**ALLENDALE CHARTER TOWNSHIP
PLANNING COMMISSION MEETING**

To: Allendale Charter Township Planning Commission
From: Gregory L. Ransford, MPA
Date: September 16, 2021
Re: M&S Storage Phase 2 Site Plan – Final Review – Resubmission

SITE PLAN M & S STORAGE 5280 & 5240 EDGEWAY DR.

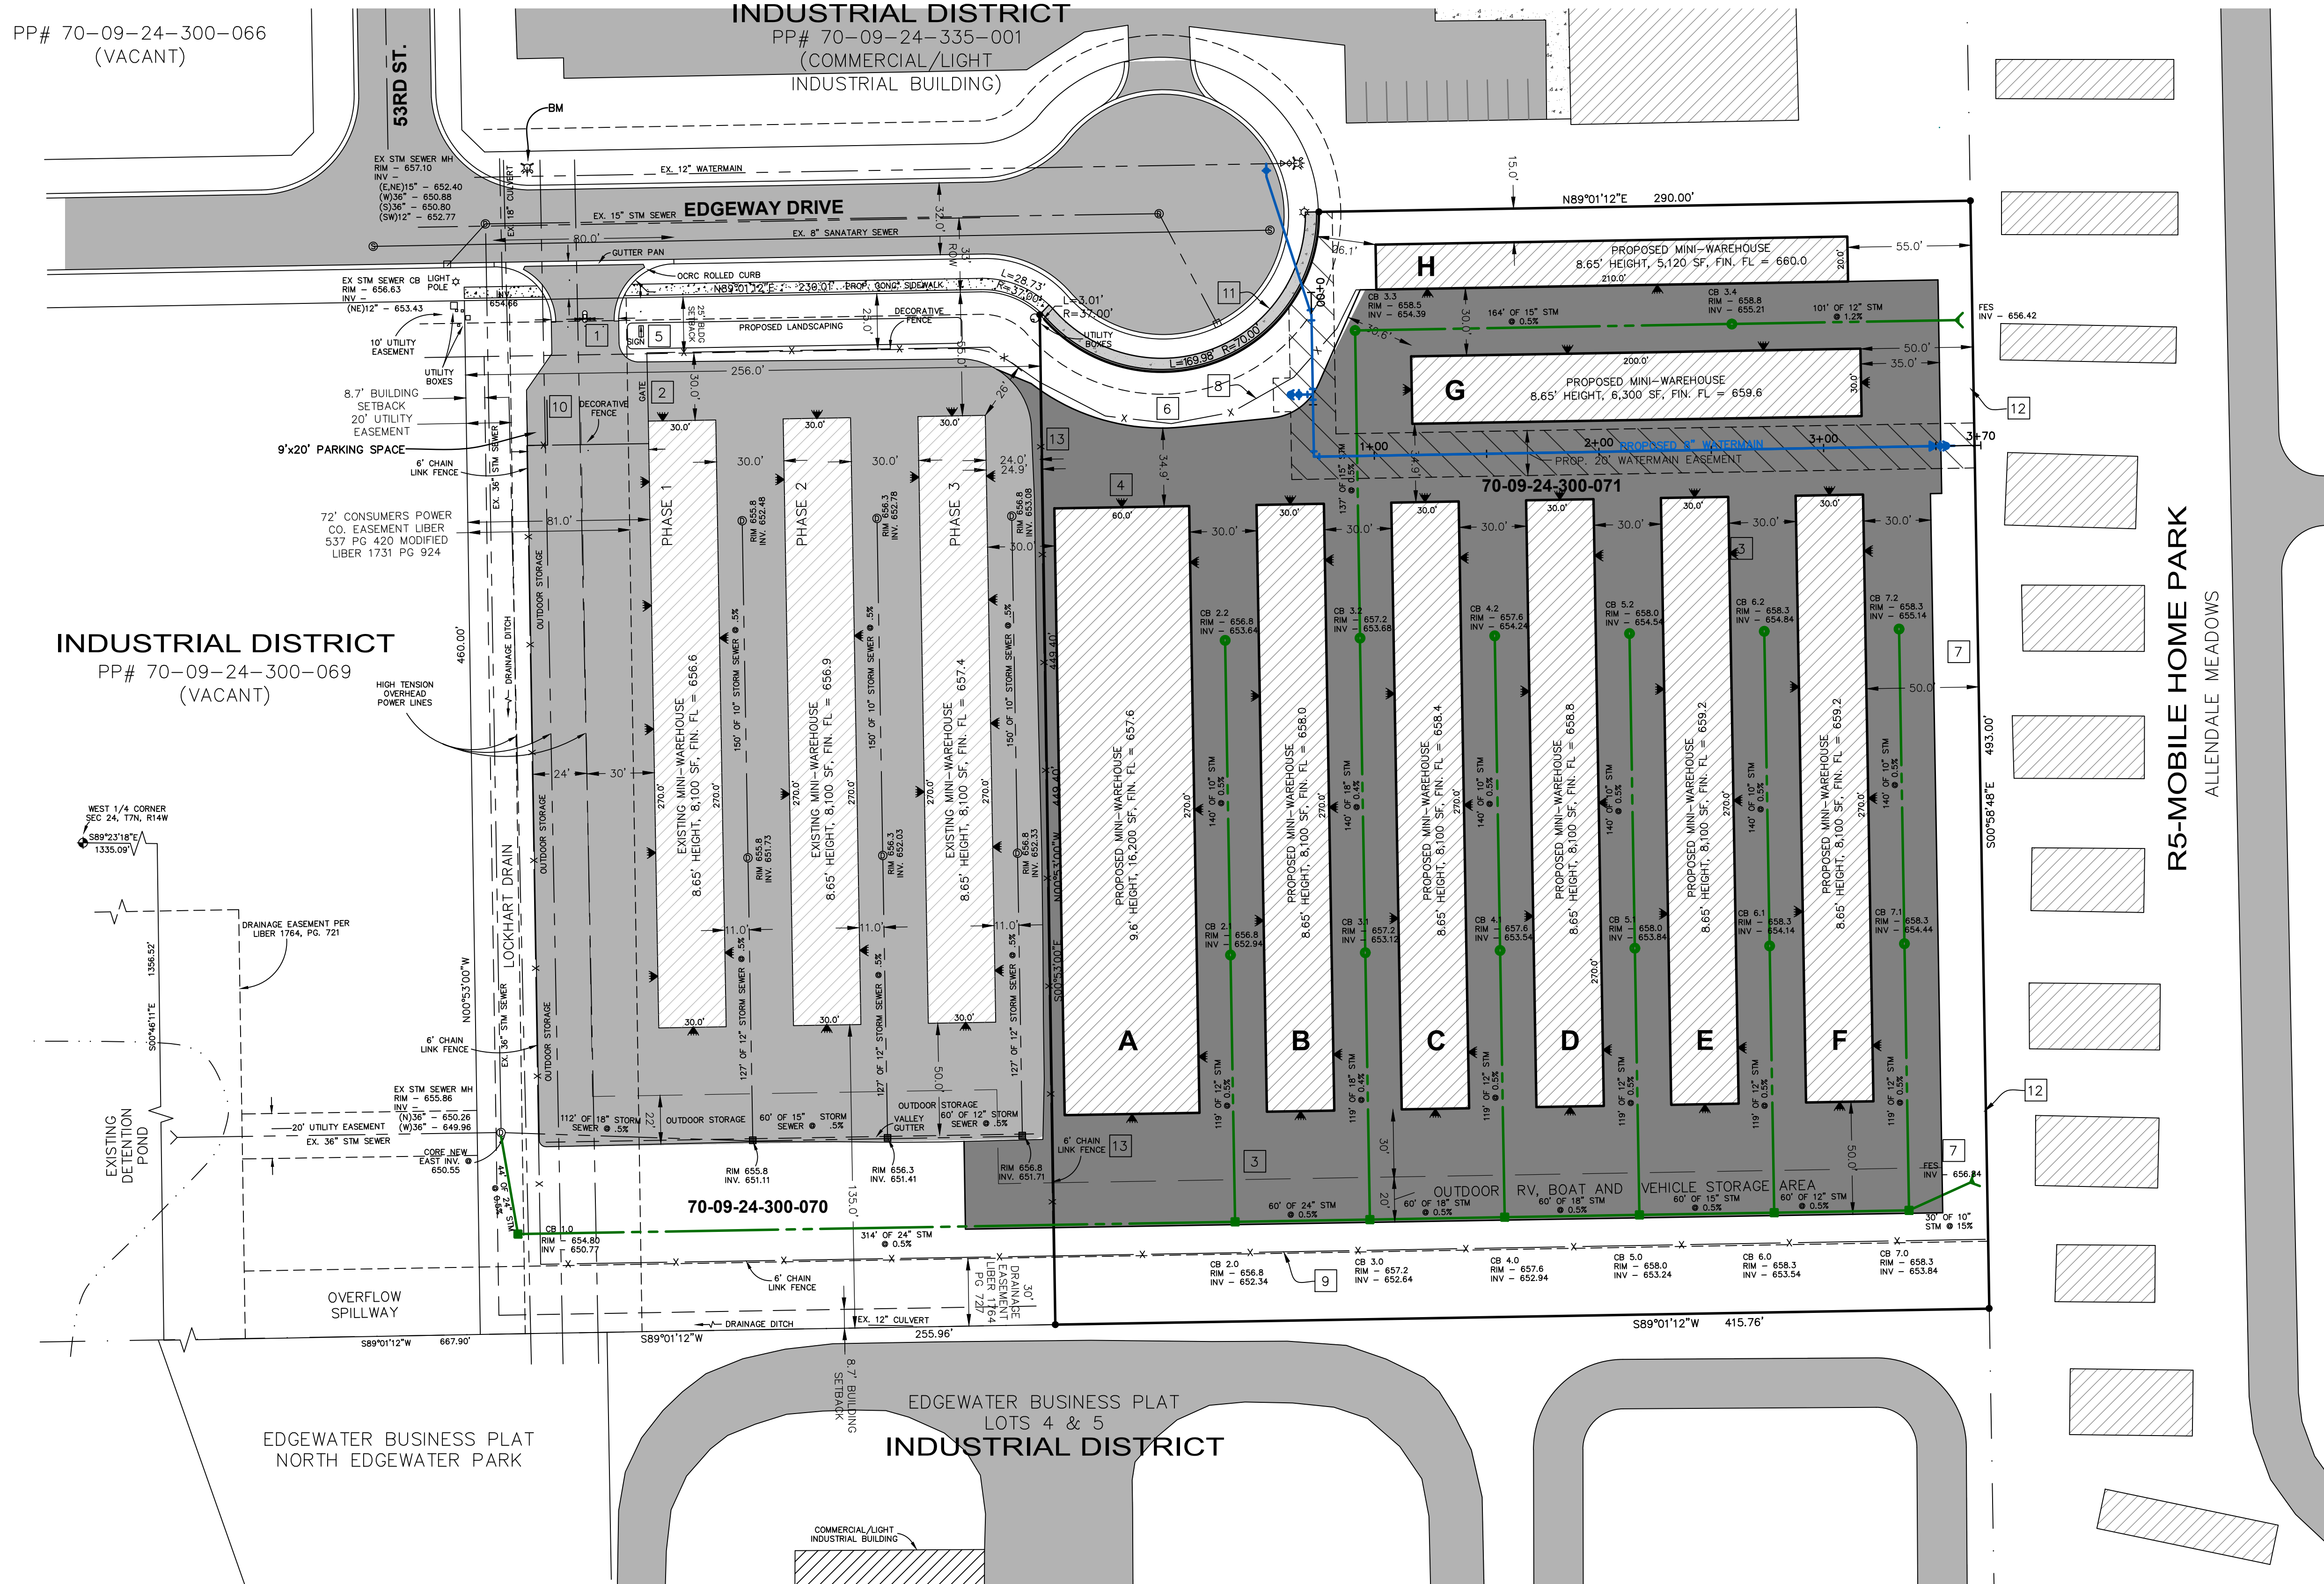
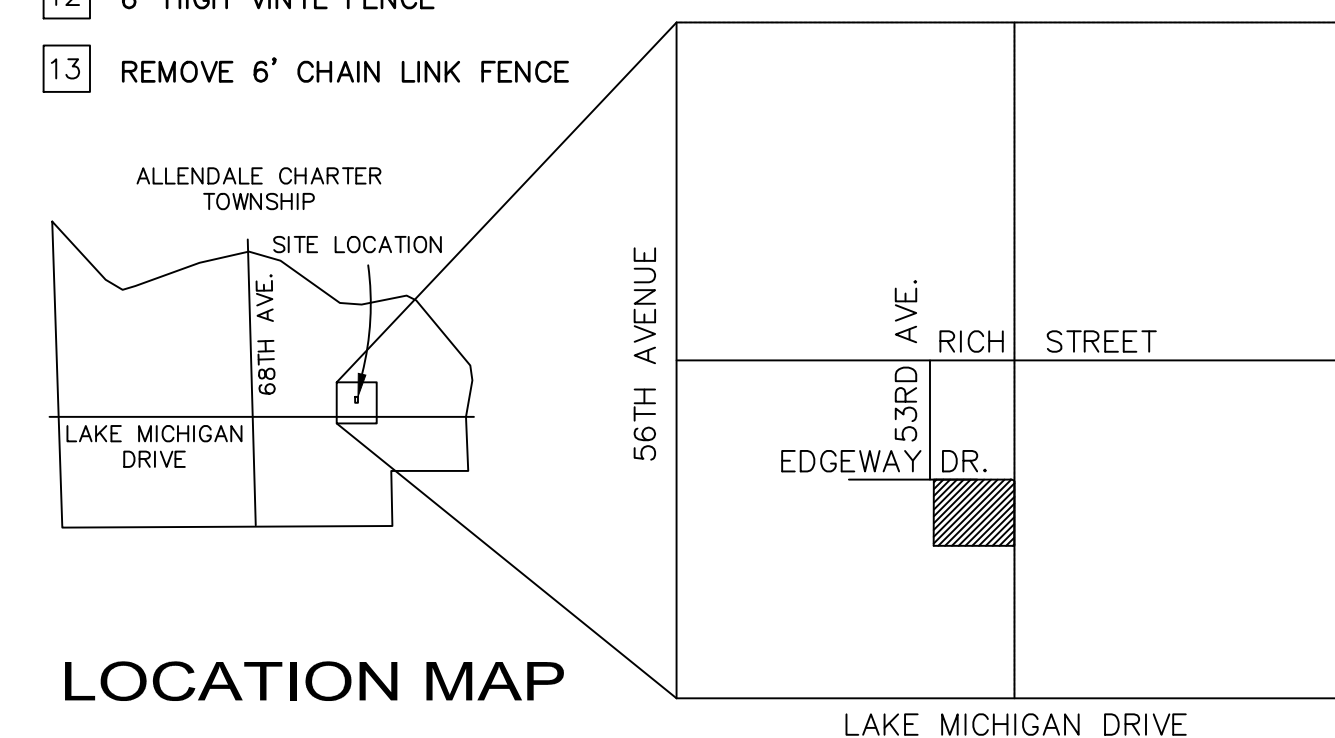
As you know, at your September 7, 2021 meeting you directed the applicant to perform the following changes to the submission and reached consensus on certain elements of the site plan materials:

- Install vinyl fencing on the east property line
- Install chain link on the south side of the property without slats
- All fencing will be 6 feet tall and well-maintained

- The elevation of Building F is acceptable
- The fence between the new and existing buildings should be removed from the plans
- Building H setback should be changed from 10 feet to 15 feet from the north property line

- The building layouts should match between the site plan and the landscape plan and all tables should be updated accordingly
- Landscaping should be increased at the southeast corner

- Black Hill spruce or a similar evergreen should replace those proposed along the east property line so their mature height and width is not too great, and the evergreen trees should be grouped in three by each building light on the east side of Building F, shifting the maples accordingly

- A plan note that new electrical and phone lines shall be buried underground

We believe the applicant has satisfied your direction. Our only item of note is the applicant was unable to update the photometric plan to match the new setback for building H in time for your upcoming meeting. Given the backlog of labor needs, we felt it was appropriate to allow the applicant to proceed. As a result, we recommend that approval is conditioned on the photometric plan being revised accordingly prior to construction.

- EXISTING KEYPAD
- EXISTING GATE
- BITUMINOUS PAVEMENT
1-1/2" 36A TOP COURSE
1-1/2" 13A BASE COURSE
6" 22A GRAVEL BASE
12" SAND SUBBASE
- WALL PACK, WALL MOUNTED LIGHT (TYP.)
MOUNTING HEIGHT OF 8 FT, FULL CUTOFF
- EXISTING GROUND MOUNTED SIGN PER TOWNSHIP ORDINANCE
MAX AREA = 48 SF, MAX HEIGHT = 3 FT.
- FRONT LANDSCAPING (SEE LANDSCAPING PLAN)
-PROVIDE UNDERGROUND IRRIGATION FOR ALL LANDSCAPED AREAS
-PLACE PLANTS PER LANDSCAPING PLAN
- BUFFER YARD (SEE LANDSCAPING PLAN)
- 6' HIGH DECORATIVE FENCE
- 6' HIGH CHAIN LINK FENCE
- 9'x20' PARKING SPACE
- PROPOSED 5' SIDEWALK
- 6' HIGH VINYL FENCE
- REMOVE 6' CHAIN LINK FENCE

ELECTRIC AND PHONE LINES SHALL BE BURIED.
